Our Case Number: ABP-317809-23

Re: Proposed Coolglass windfarm and related works
In the townlands of Fossy Upper, Aghoney, Gorreelagh, Knocklead, Scotland, Brennanshill,
Monamantry, Coolglass, Crissard and Kylenebehy, Co. Laois.

Re: Case PA11.317809: Submission to An Bord Pleanála Case PA11.317809 In the townlands of Fossy Upper, Aghoney, Gorreelagh, Knocklead, Scotland, Brennanshill, Monamantry, Coolglass, Crissard and Kilenabehy, Co. Laois.

Proposed Coolglass Windfarm Development and related works.

Figure 2: Screenshot from SEAI Wind Mapping System

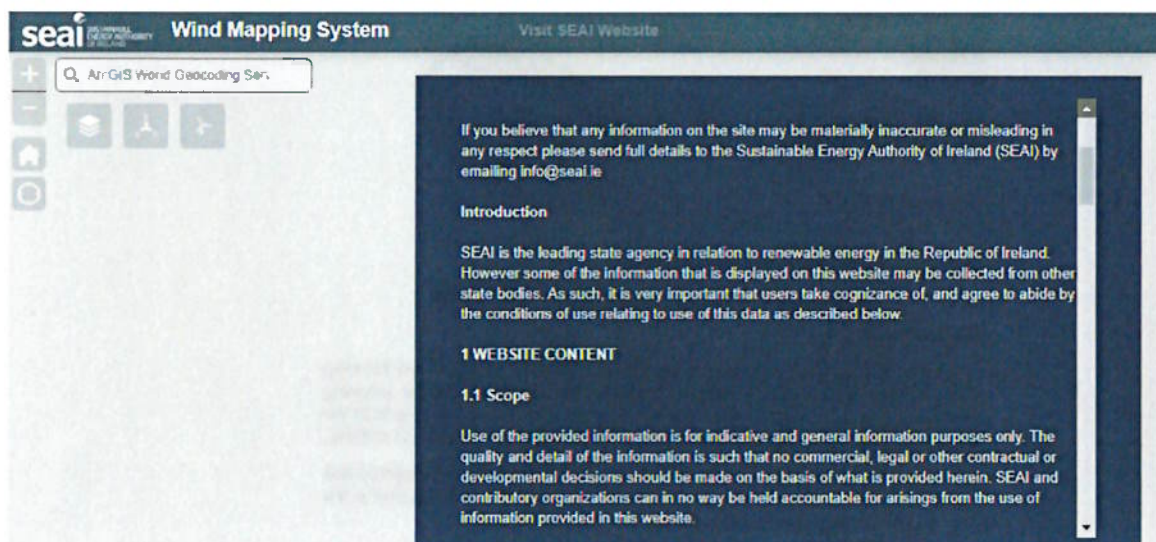
However, as stated on the SEAI Wind Atlas website (<https://gis.seai.ie/wind/>) section 1.1 scope (see screenshot in Figure 1 below):

“Use of the provided information is for indicative and general information purposes only. The quality and detail of the information is such that no commercial, legal, or other contractual or developmental decisions should be made on the basis of what is provided herein.”

There is no evidence that a site wind resource analysis using wind anemometers and measuring masts was carried out for the proposed windfarm.

There is no evidence of this measured wind speed data from the proposed site with the application which is therefore contravening the Laois CDP.

Figure 4: Screenshot from maps.biodiversity.ie website showing Marsh Fritillary recordings

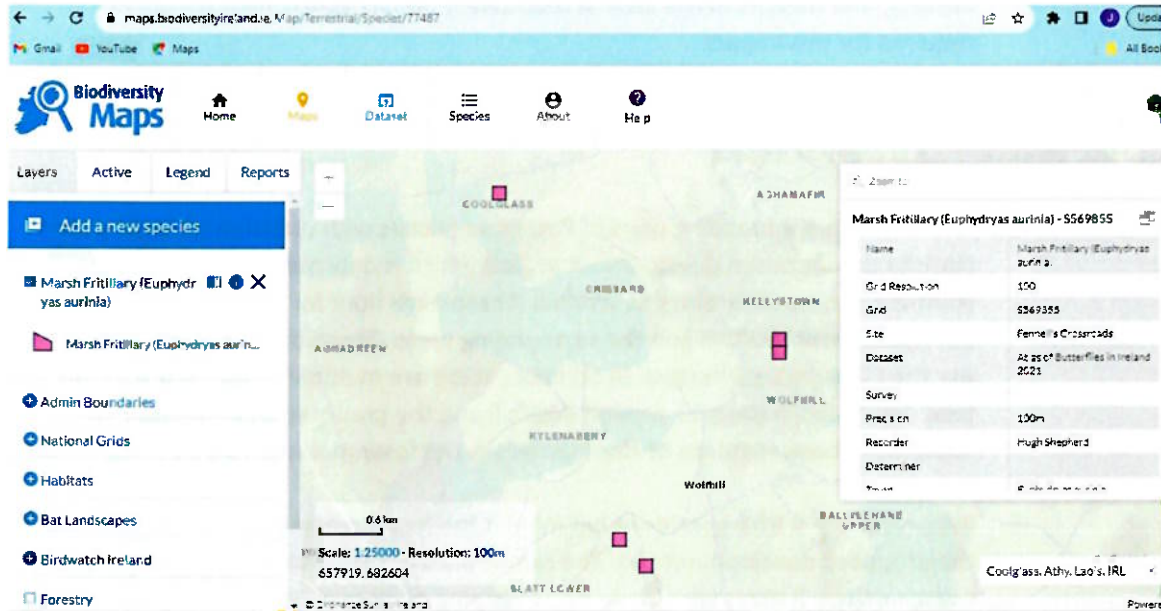
This is incorrect information from the developer. There are areas close to the forestry plantations within the site development boundary which contain Devil's Bit Scabious Succisa pratensis, the foodplant of the protected Marsh Fritillary butterfly (only Irish insect listed as Annex II protected species). It is noted no specific field study was performed for the Marsh Fritillary butterfly, as from the developer's assessment of desktop data, there are no habitats supporting the butterfly's foodplant. Per the

'maps.biodiversityireland.ie' there have been multiple recordings of the Marsh Fritillary in Coolglass, Wolfhill and The Swan in years. See figure 4 below.
A proper field study should be required due to the presence of *Devil's bit scabious* *Succisa pratensis* at the proposed development site.
